STAFF REPORT

Hall Preliminary & Final Subdivision Review

Preliminary & Final Subdivision Review of Kenneth D. Hall's Proposal for a 2-Lot Subdivision

Docket #: DRB-17-18

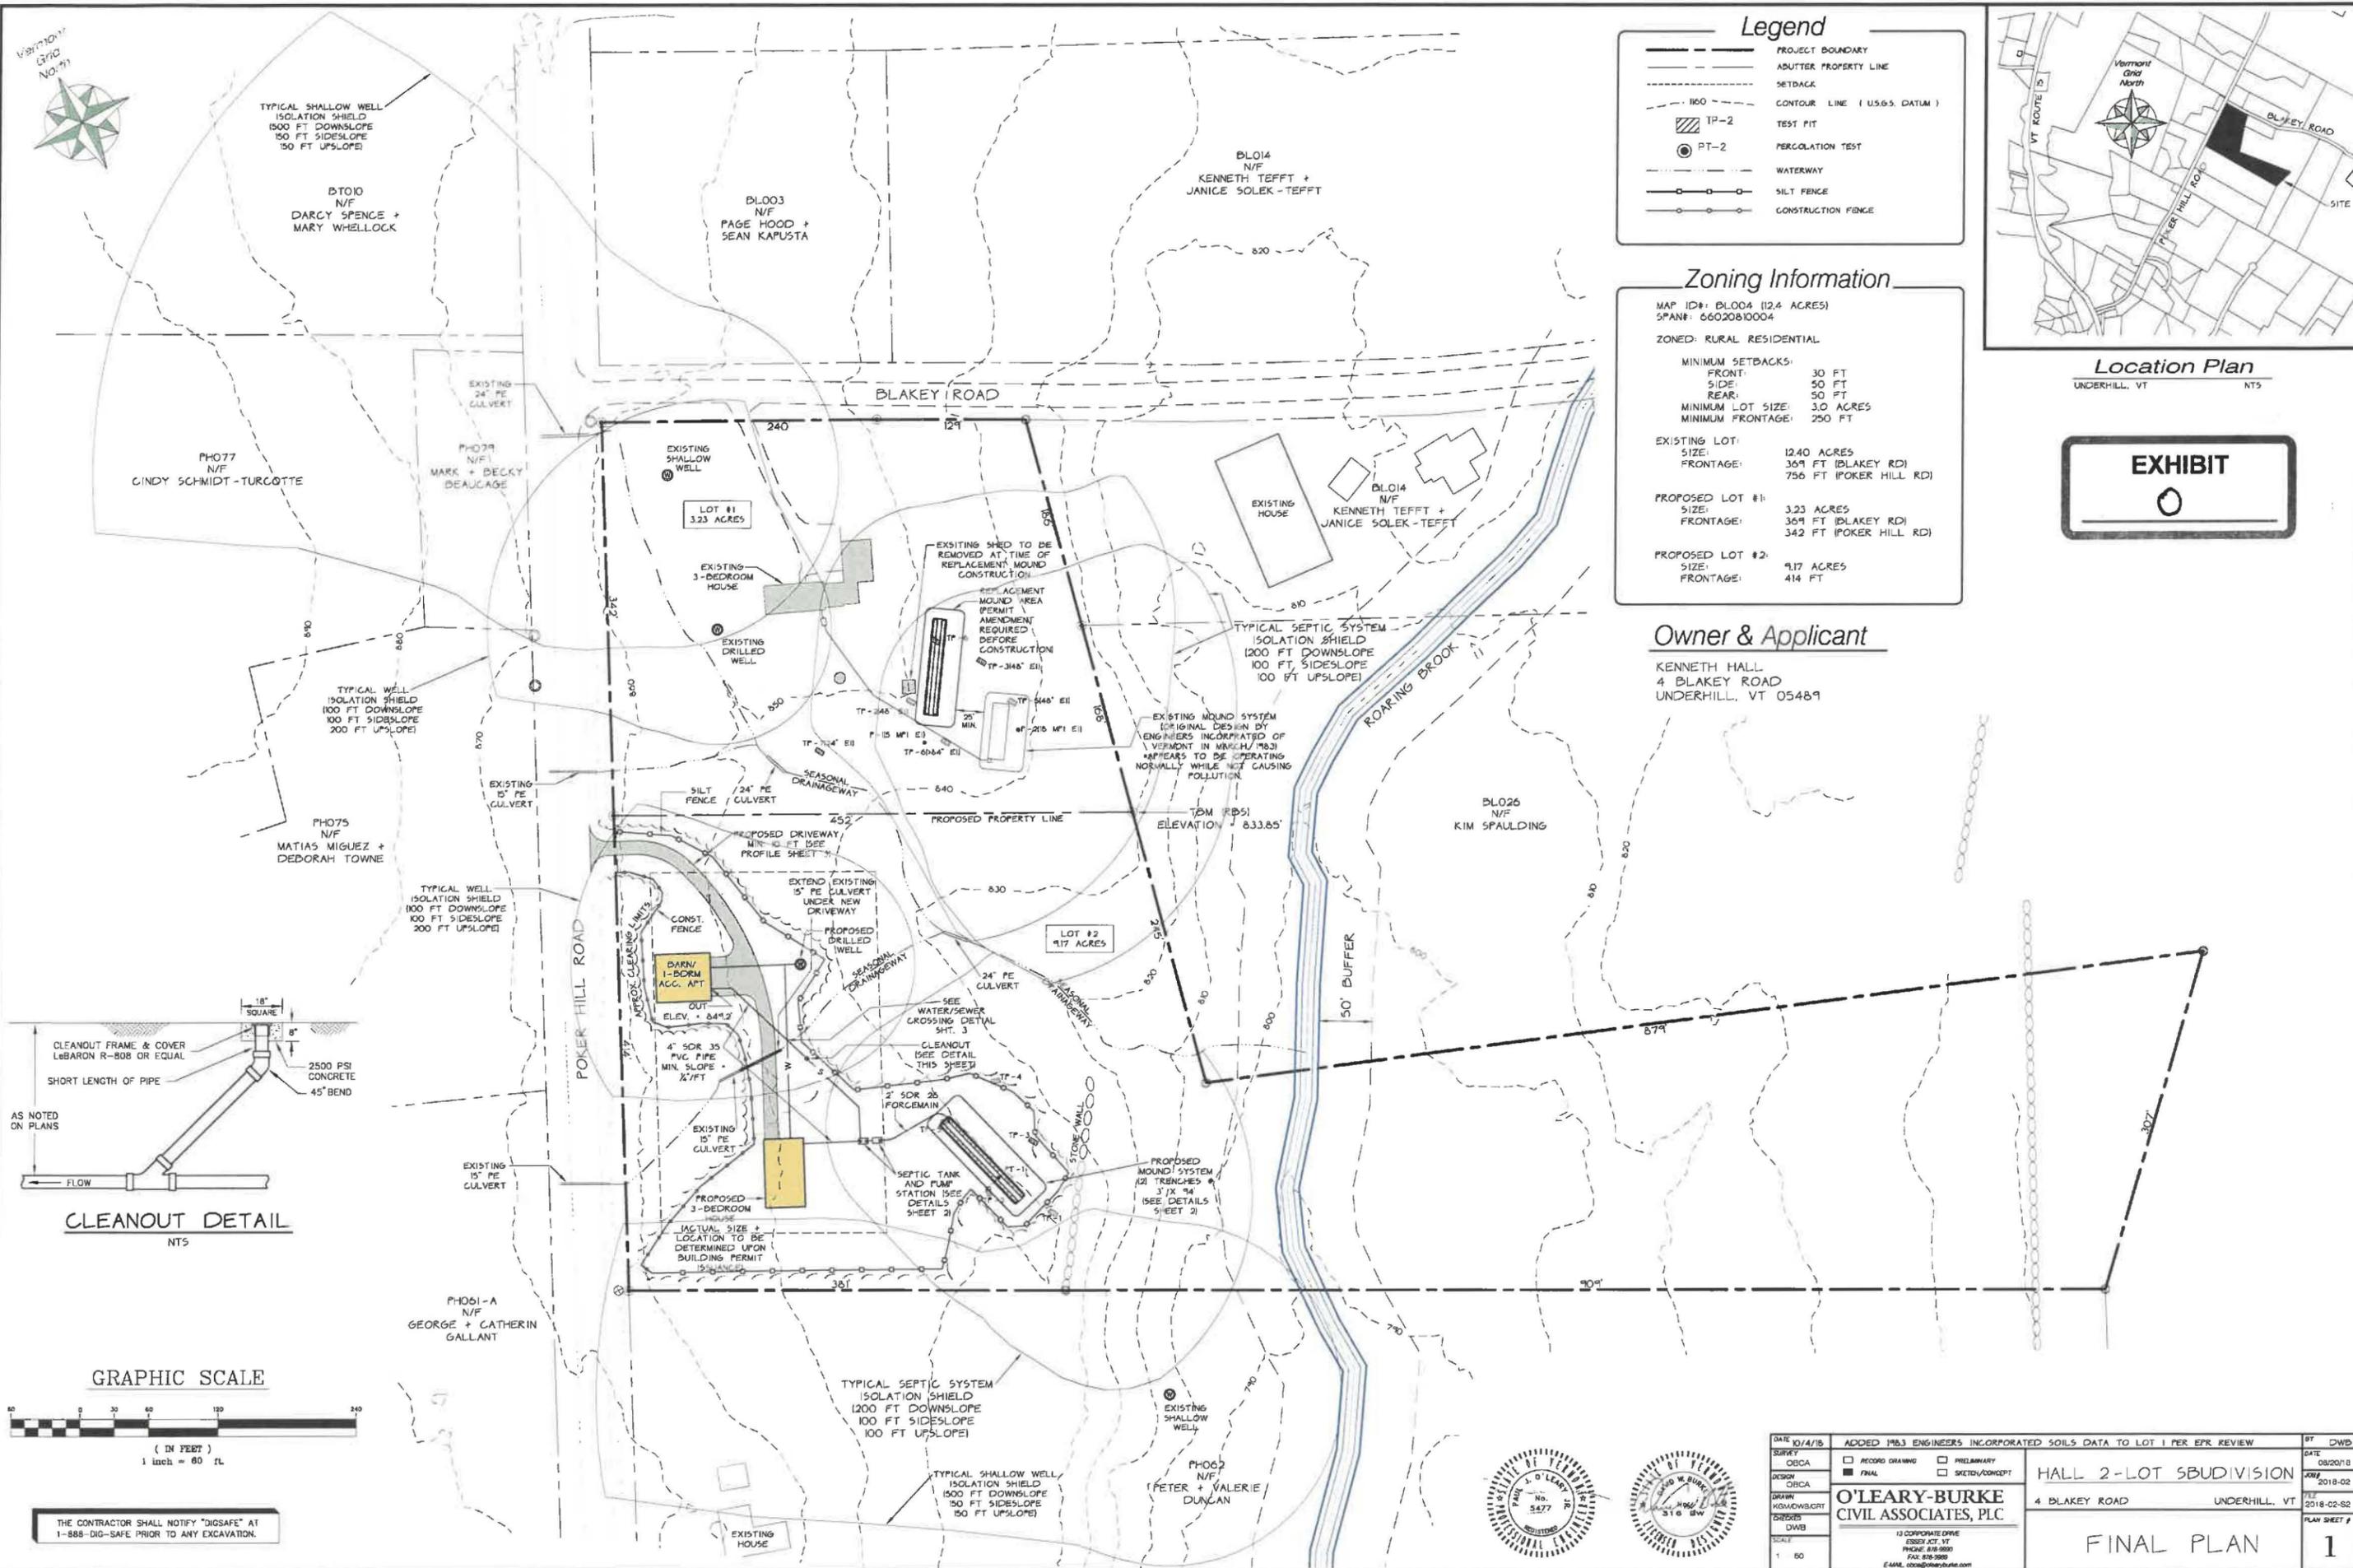
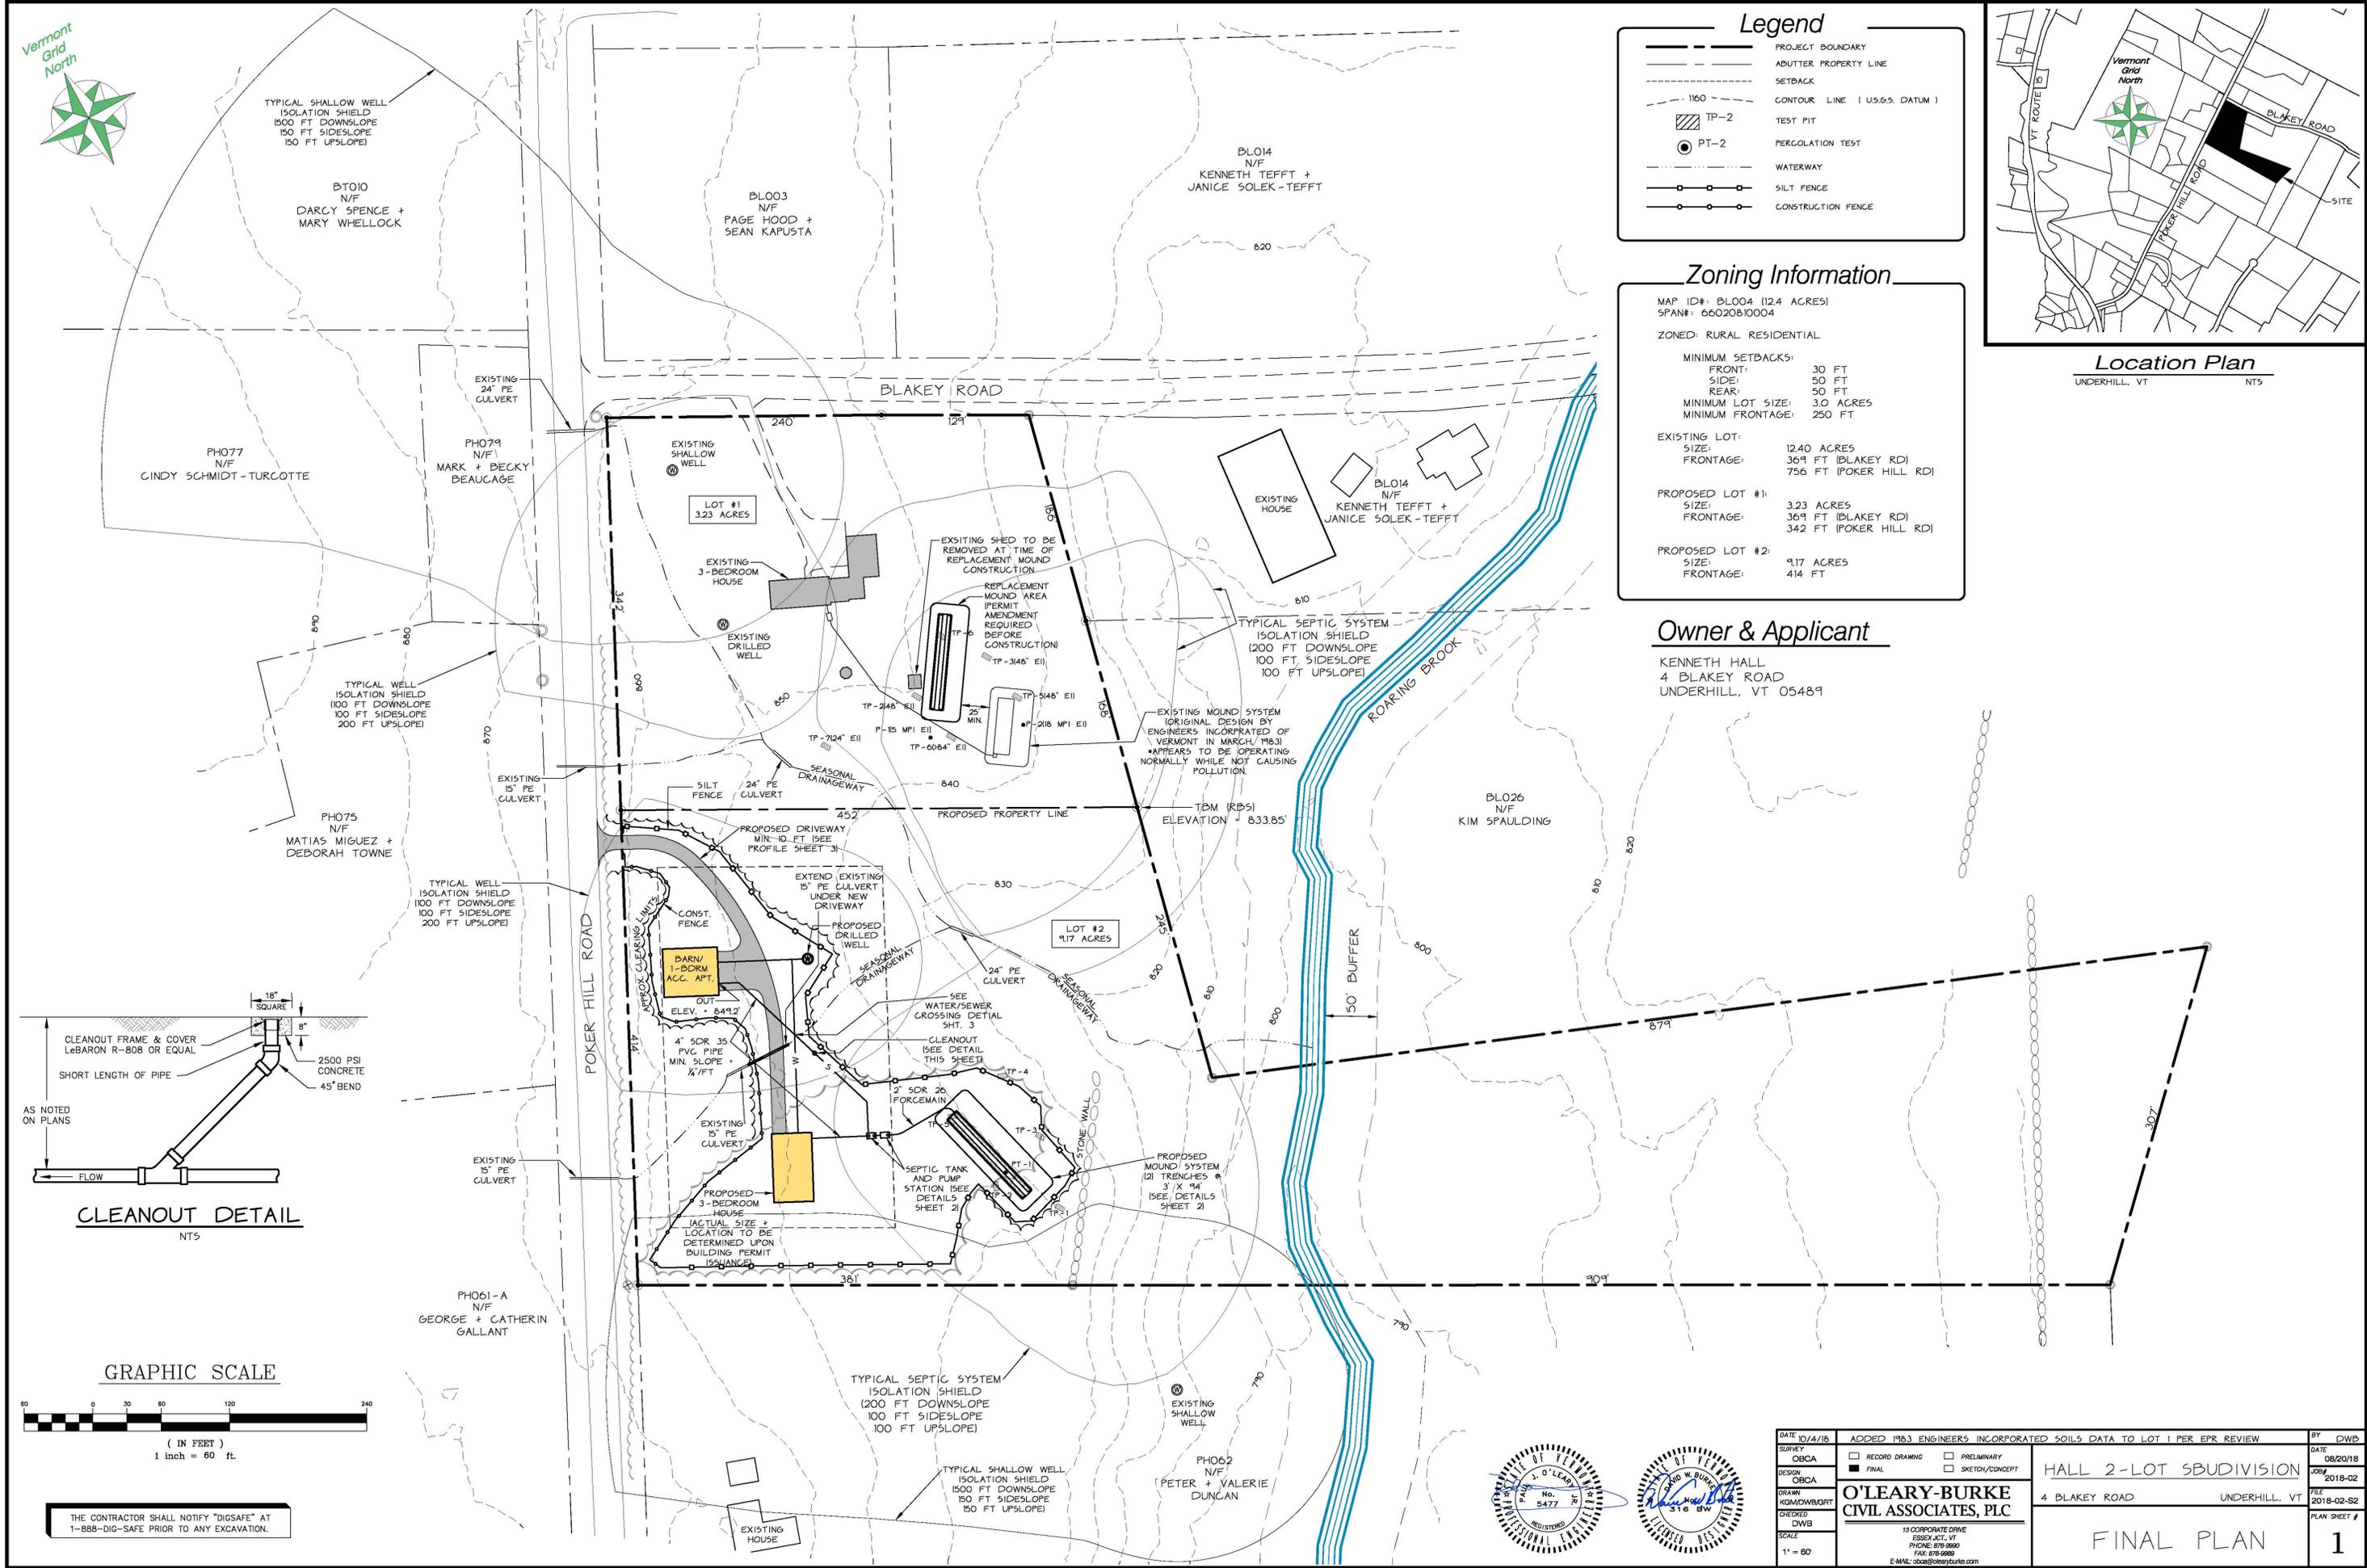
In response to condition 2, the applicant has submitted a site plan depicting Roaring Brook; however, has not depicted the associated Special Flood Hazard Area encompassing Roaring Brook. No wetlands were depicted, presumably because none were found (see Exhibit O).

In response to condition 8, the applicant has submitted a site plan depicting the requested features except for the Special Flood Hazard Areas (see Exhibit O).

In response to condition 10, a preliminary access permit has been obtained from the Selectboard (Access Permit #: A-18-22) (see Exhibit L). Staff notes that the applicant did not depict a driveway layout containing a 15 ft. by 37.5 ft turnaround around. As a result, the Selectboard, as a condition of approval, required this feature, as well as ensuring that all curvatures satisfy the 35 ft. radius.

DATE 08/10/18
JOB# 2018-02
FILE # 2018-02
PLAT #
PLAN SHEET # PL1

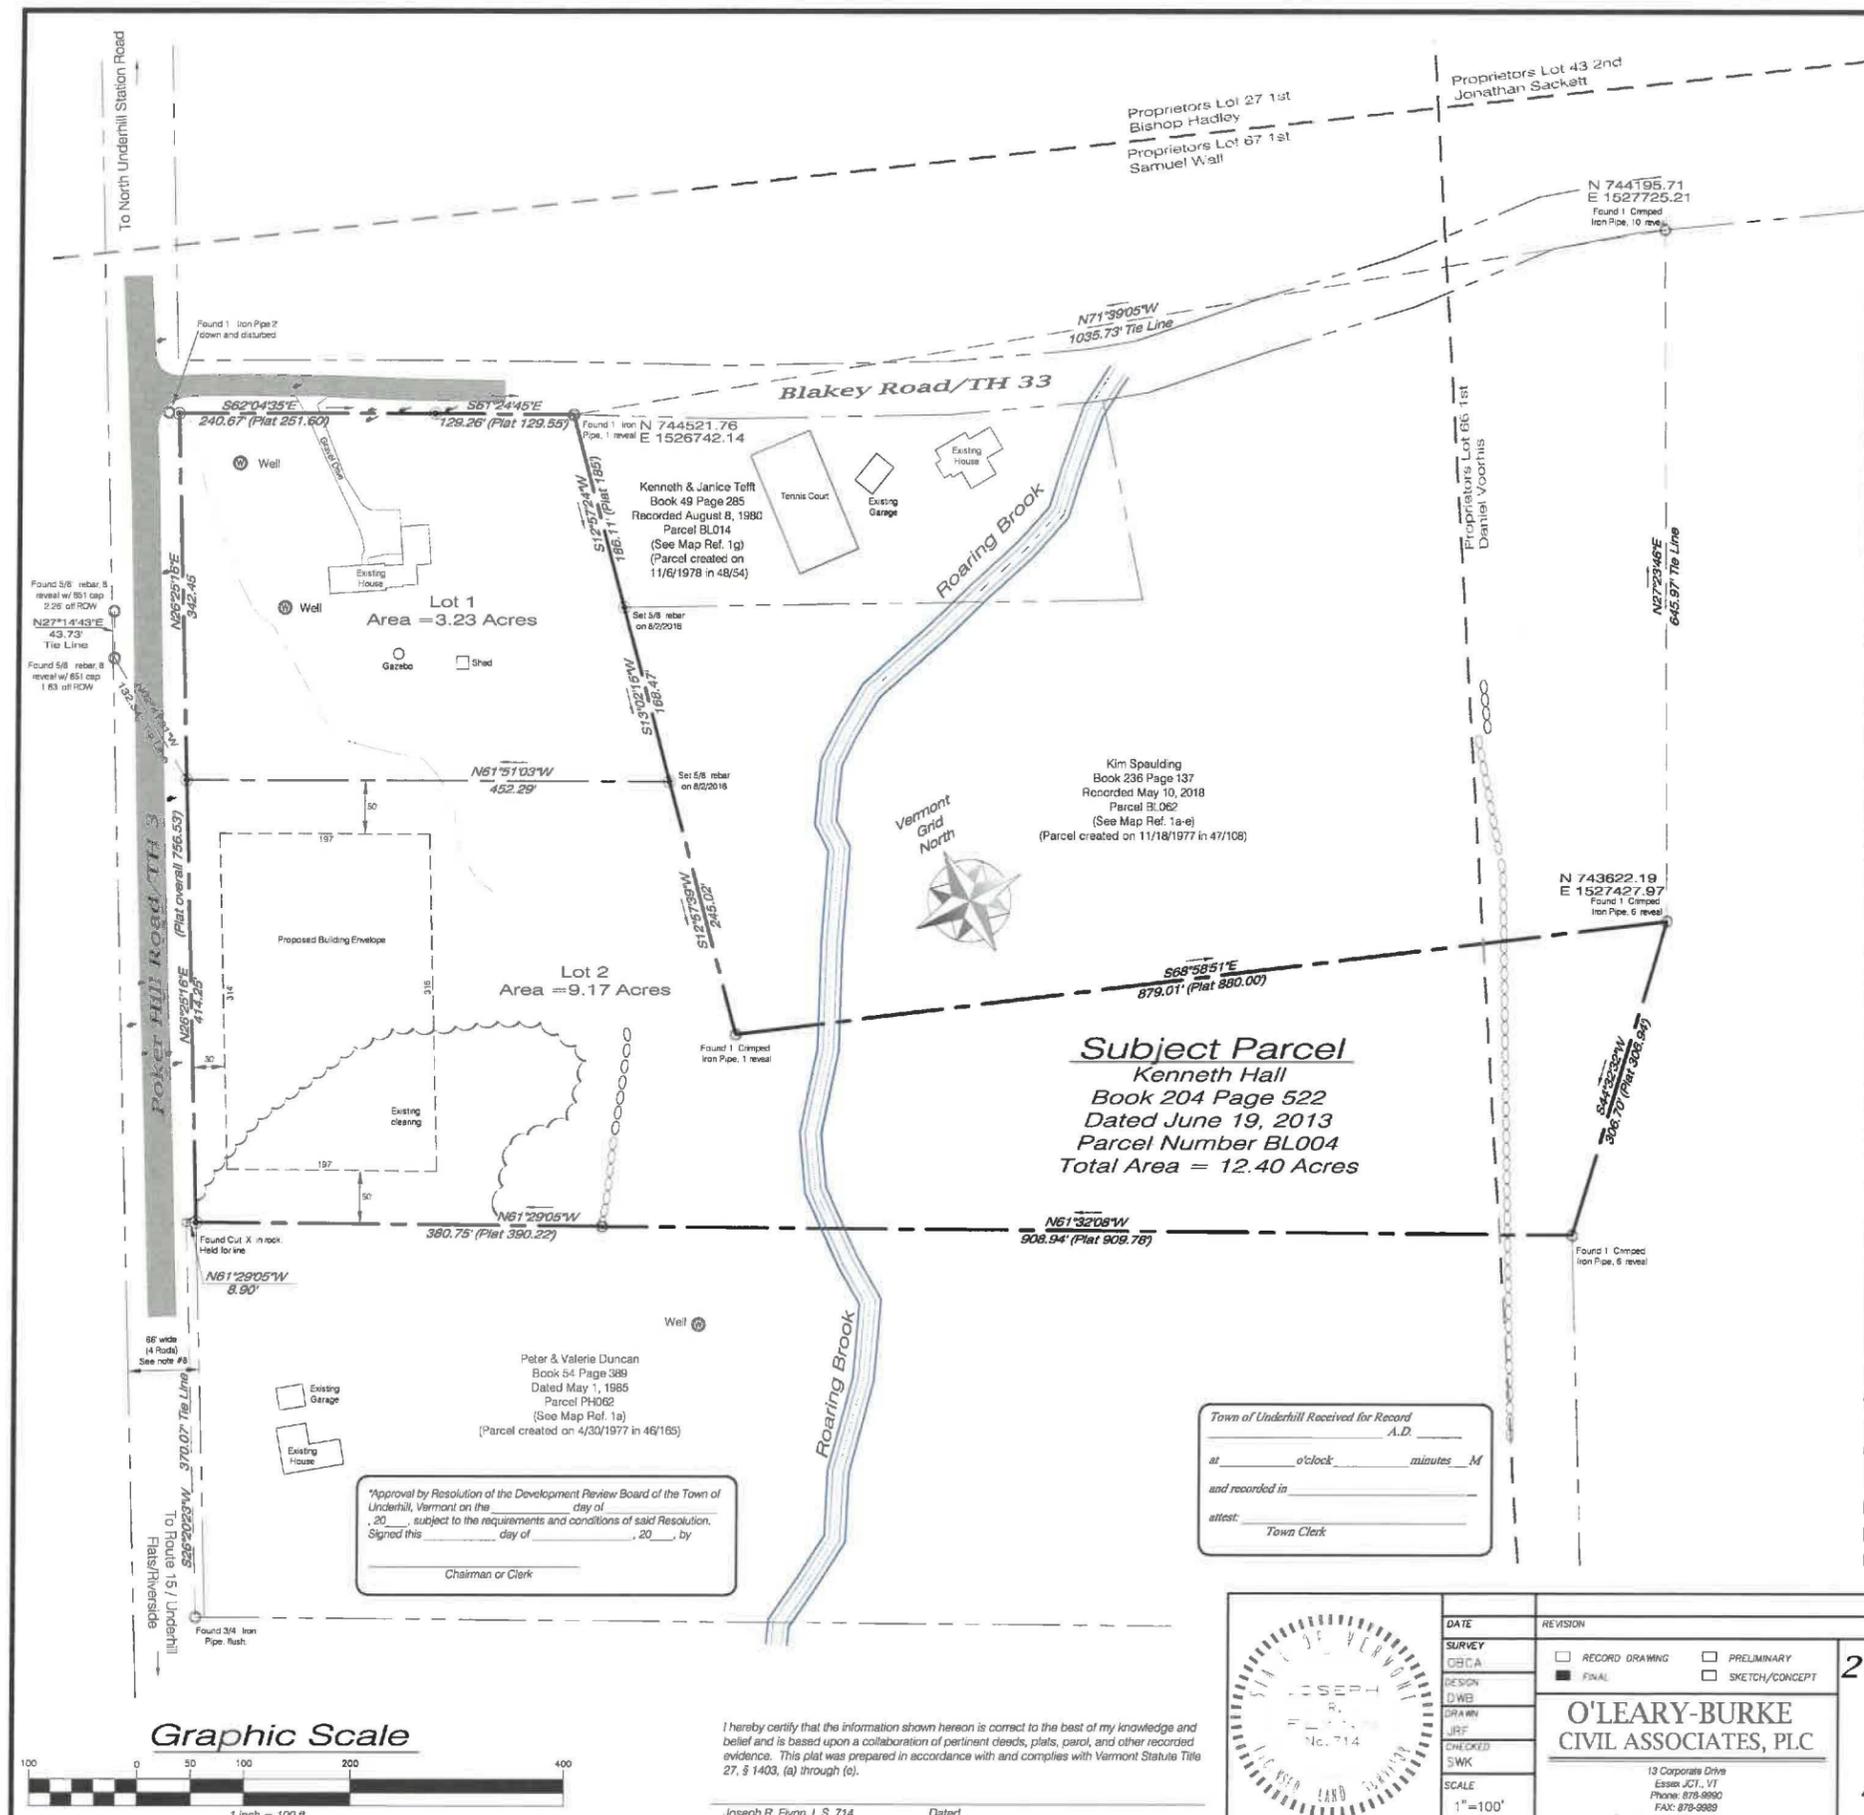
In response to condition 3, a survey plat has been submitted – completed by Joseph Flynn. No easements have been depicted (see Exhibit R).

When reviewing the survey markers that have been placed as a part of the subdivision effort, it seems that the southeast border of our property was incorrectly marked. When comparing the map provided in Exhibit G – Existing Lot Configuration that was provided as a part of, DRB-17-18: Hall Sketch Plan Review (BL004 - 4 Blakey Road) against the boundaries generated electronically for other maps such as Exhibit L from the same location, and from the map of our own purchase of the property on 26 Blakey Road it appears that Exhibit G (and also the survey) used a map that does not reflect property changes since 1980 when the map was generated such as the 1997 subdivision of the 15.64 acres marked Sebring to Goetz in Exhibit G.
